**C L E P A**  
*European Association of  
Automotive Suppliers*

# 54<sup>rd</sup> Meeting Informal Group on Child Restraint Systems

## Booster Seat Width Development

27<sup>th</sup> October 2015

R129 Booster Seat  
width 440mm

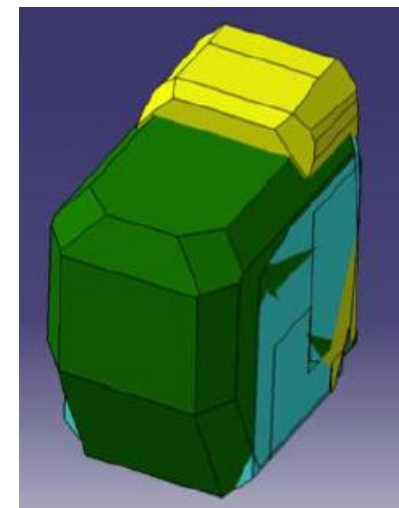
• Subjected to same consumer tests (Q3, Q6, Q10)

• Experience same real world use in vehicles & accidents

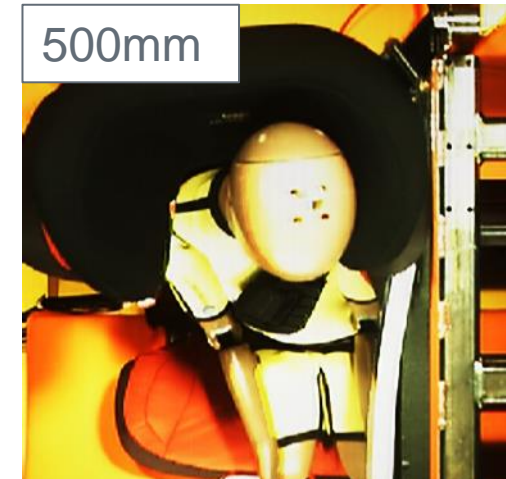
Aim: Allow 3x Booster Seats in rear of family vehicles

Question: What is potential safety reduction?

500mm

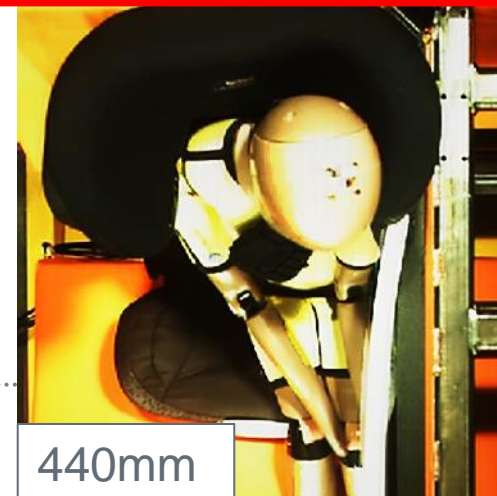
All dummies have poorer head support

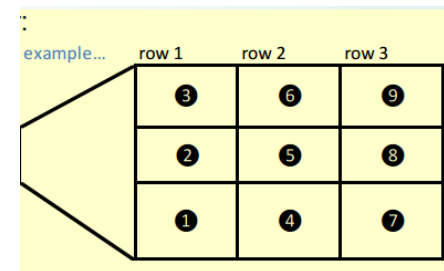
Q6 not representative of a seated 135cm child

Based on CLEPA proposal Q10 should still be used to test booster seats – enhanced safety over R44 CRSs
